RIVERSIDE
REGIONAL MEDICAL CENTER

Harold Prussia
License No.: 45-09001-01
Docket No.: 03003330
Control No.: 138016
December 9, 2005

To Sandra Gabriel:

This letter is in response to your request for additional information. Our response will answer each question with the same numbering system as in your letter.

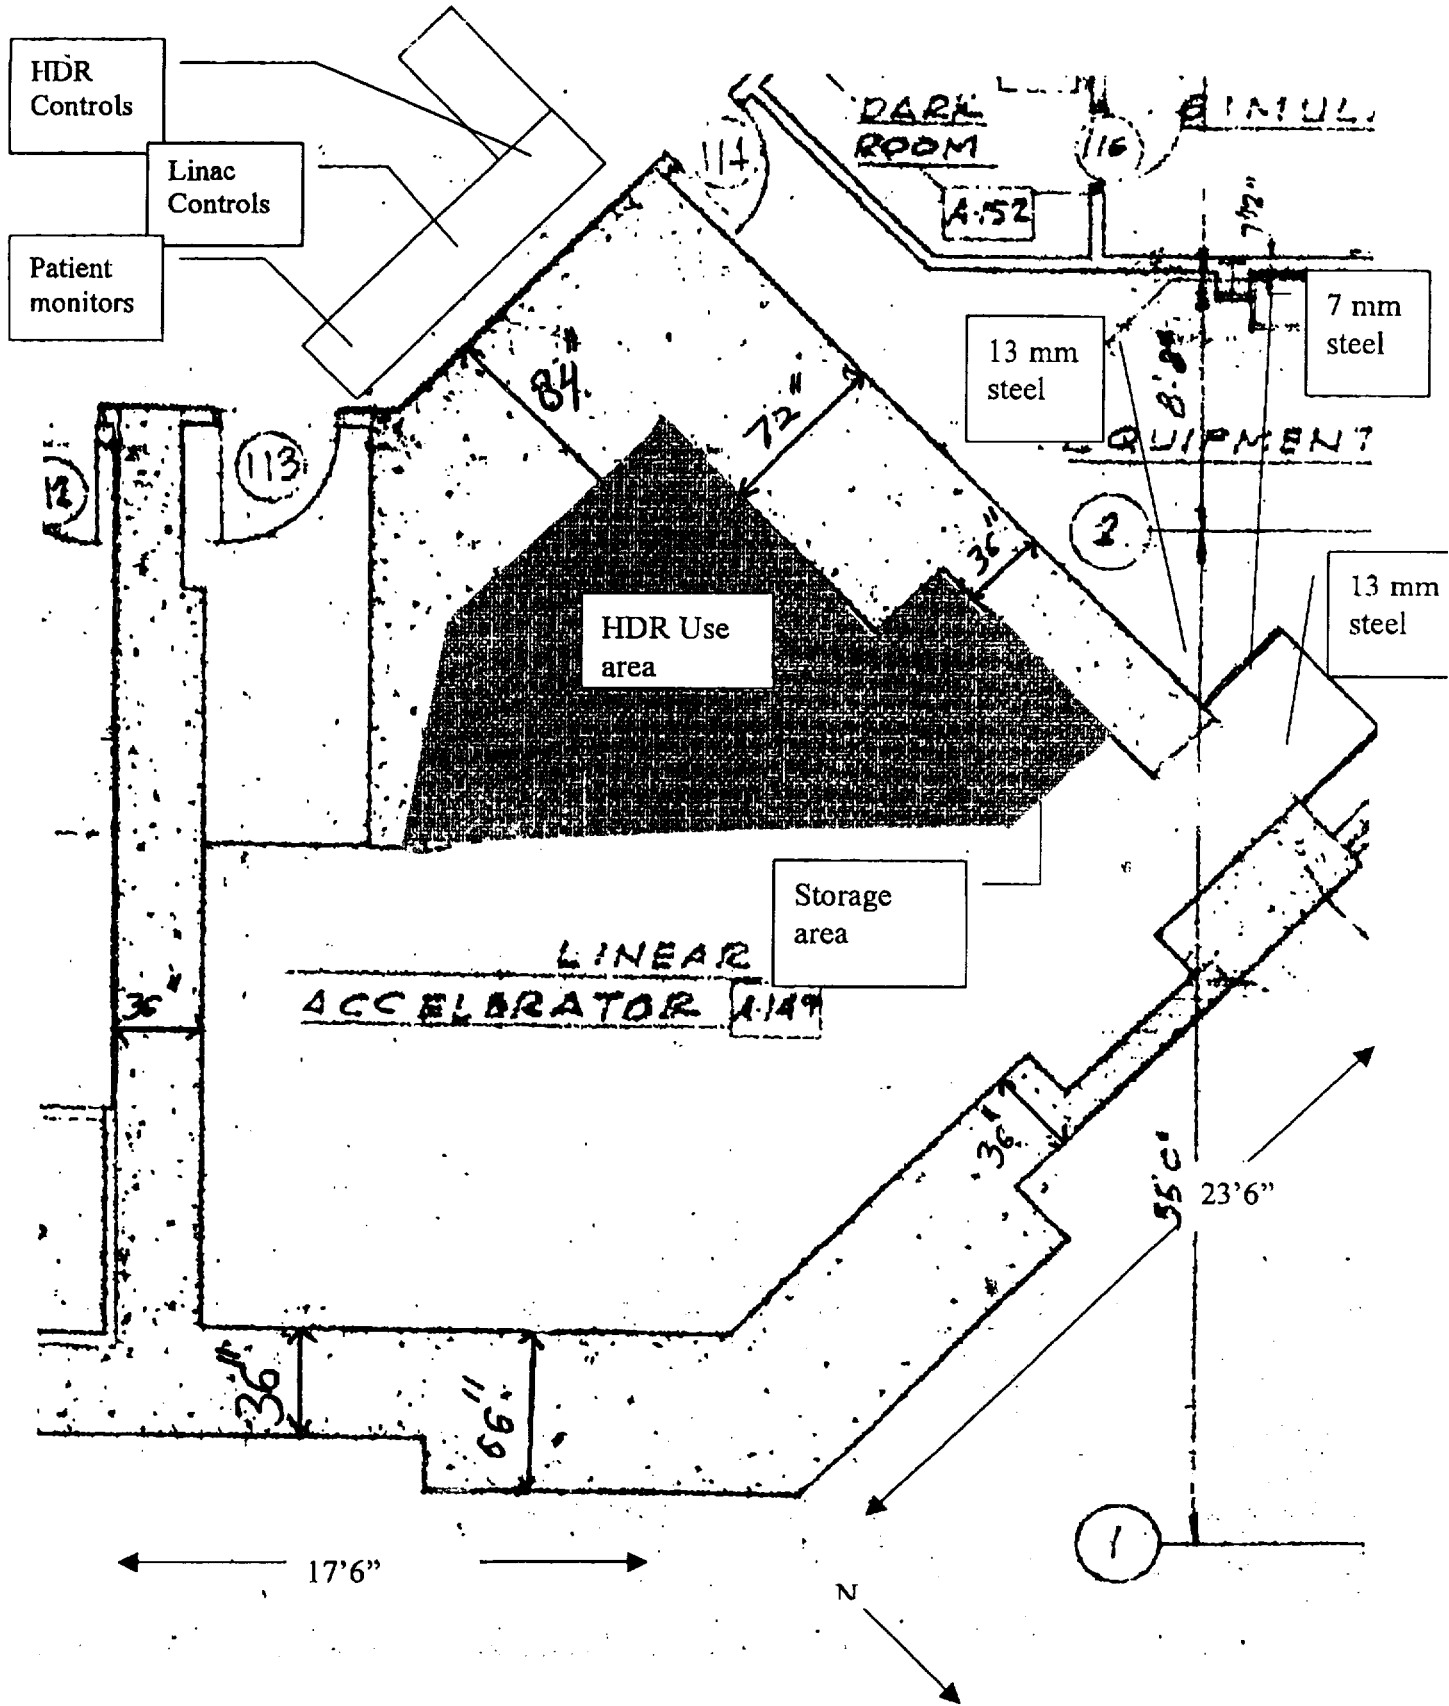
- 1)a). We have added the location of the HDR control panel to the drawing that was on page 6 of our original correspondence. The enhanced drawing is on page 3. of this response.

signs are posted on the outside of both doors before inserting the key in the HDR control. The appropriate door signage will comply with 10CFR20 and be determined by the results of an area survey with the source at point B in the drawing on page 3. The door signs will be attached by Velcro and removed after the control key has been removed from the HDR unit.

Response to Item 1b. See attached diagram

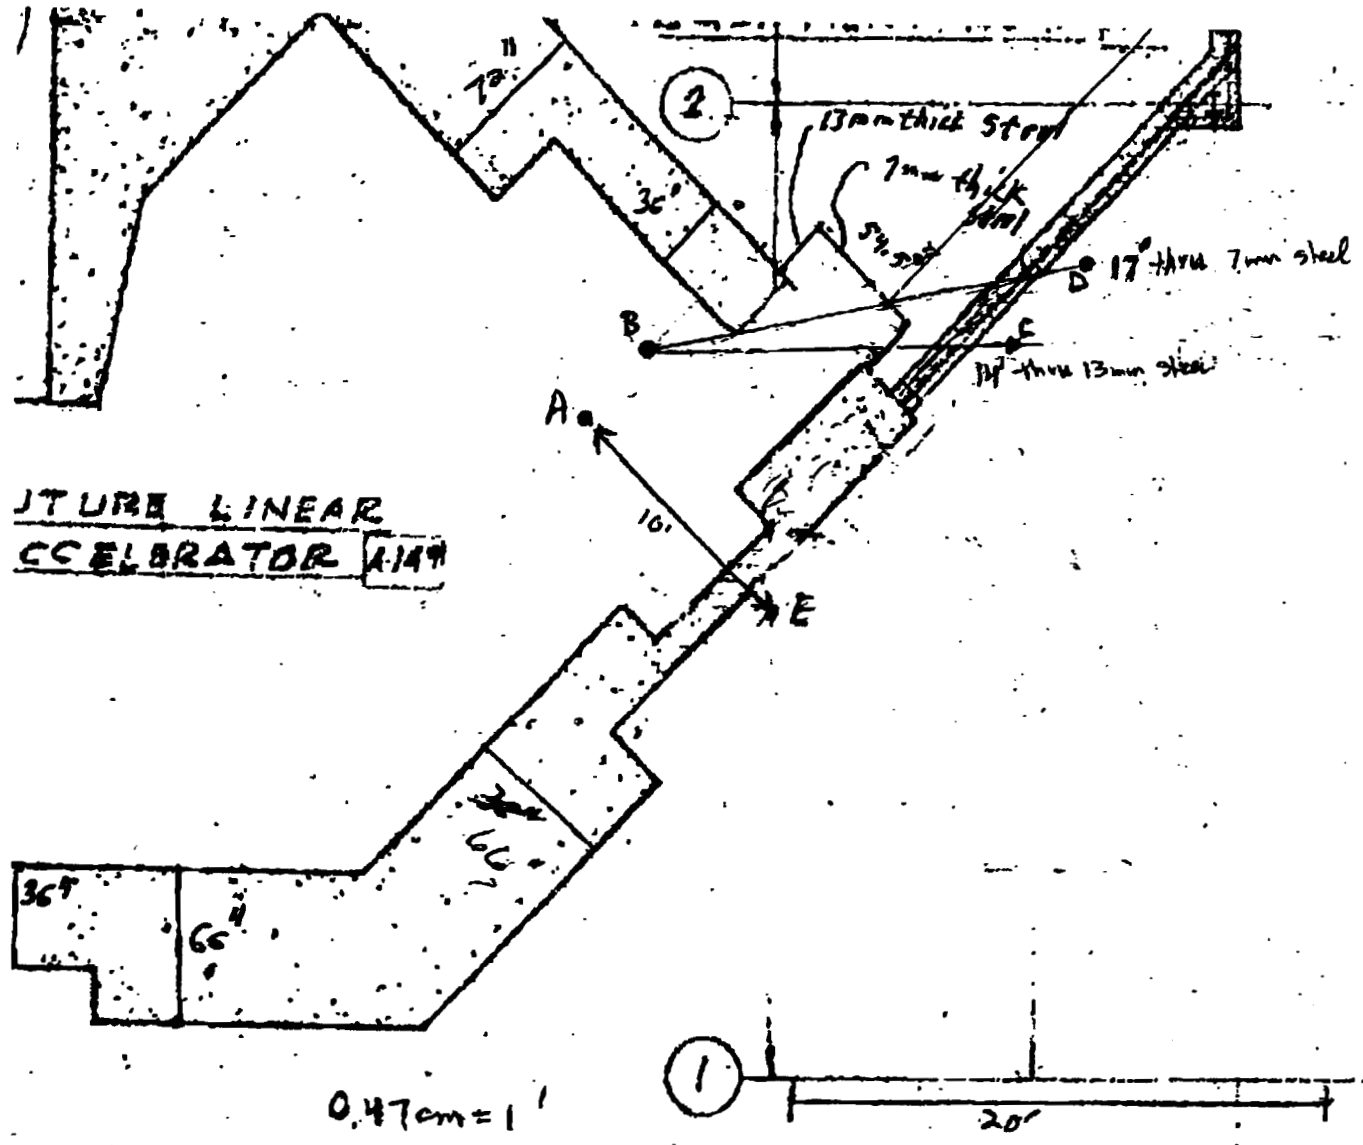
- 1)b). A more detailed explanation of the barrier calculations and drawing are on page 4 and 5 of this response. The added information and drawings along with the original calculations document the values and location of requested calculation points.

- 4). We confirm that the doses to individuals in areas beyond the equipment room will not exceed regulatory limits. Please see the attached explanation and drawing on page 4 and 5 of this response.

Point A is the source location assumed for the dose calculation beyond the knockout wall at point E. This source location is outside the designated source usage area, closer to the knockout wall than any point inside the designated usage area. Accordingly, it is used to demonstrate that dose to the public beyond the knockout wall is within regulatory limits even if the source is used closer to the wall that indicated by the designated usage area.

Point B is the source location assumed for the dose calculated at points C and D beyond the equipment room. Note that this source location is also slightly outside the designated use area, and permits radiation to pass through the steel cage, avoiding any of the thick vault concrete walls. Like the above, it is used to demonstrate that dose to the public outside the building beyond the equipment room are within regulatory limits even if the source is used outside designated usage area.

Point C is beyond the equipment room, through the 13 mm section of the steel cage, one foot beyond the outside wall.

Point D is beyond the equipment room, through the 7 mm section of the steel cage, one foot beyond the outside wall.

Point E is outside, one foot beyond the concrete knockout wall.

Beyond the equipment room is the outside parking area where points C and D are located. The dose at these points was calculated in the original report. The calculations were labeled "Yearly Dose Equivalent Outside the Building, Beyond the 13 mm Steel Cage" and "Yearly Dose Equivalent Outside the Building, Beyond the 7 mm Steel Cage." In all instances, the dose was within regulatory limits. (Note the typographical error in the original report. The distances to Points C and D were labeled as 14" and 17" respectively. The actual distances were 14' and 17'.)
